H.Henschel, I.Tsurin		
Title Front and rear panel connectors for the supply, controls and indicators		
Size	Document Number	Rev 0
Date:	Friday, September 23, 2005	Sheet 7 of 7

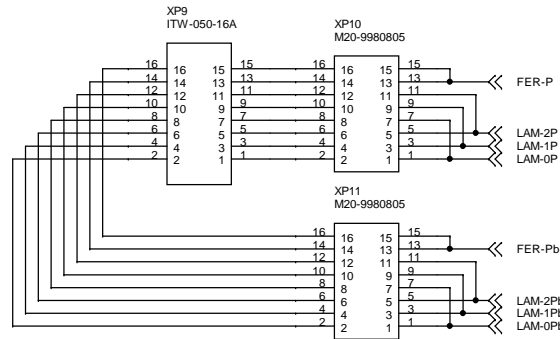
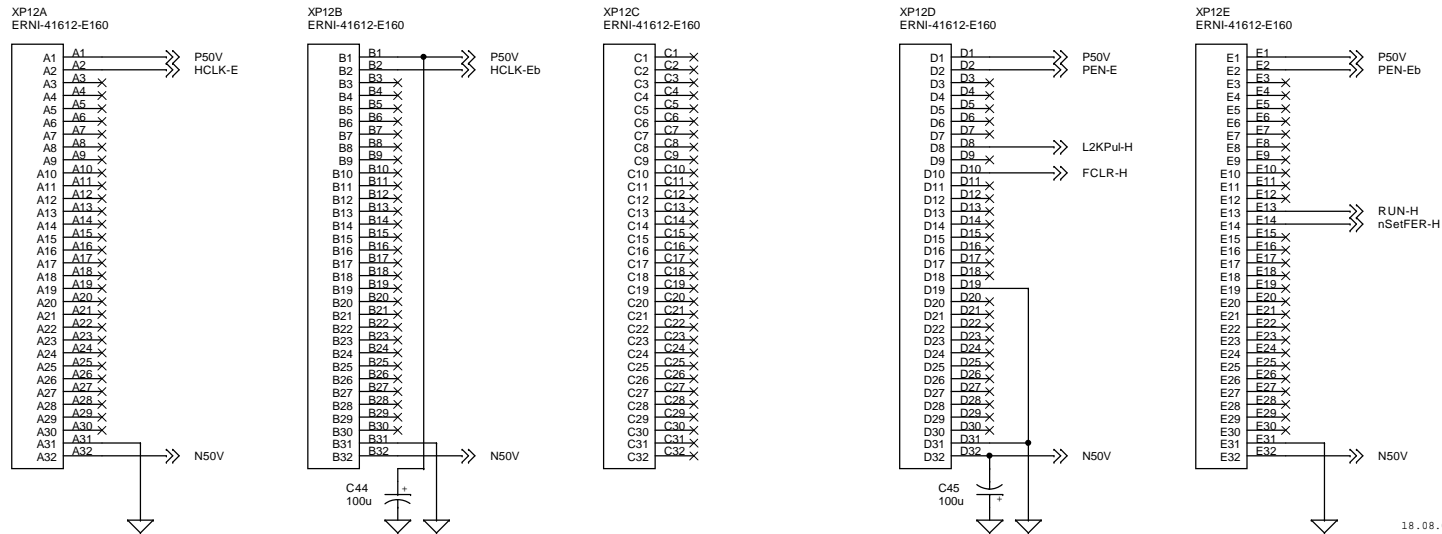
18.08.01 The layout error: drill holes of XP12 connector should have bigger isolation rings in the power and in the ground layers.

18.08.01 The layout error: all connectors and jumpers have very narrow isolation rings in the power and in the ground layers.

18.08.01 The layout error: all 0805 and 0603 footprints for resistors and capacitors are smaller, than necessary.
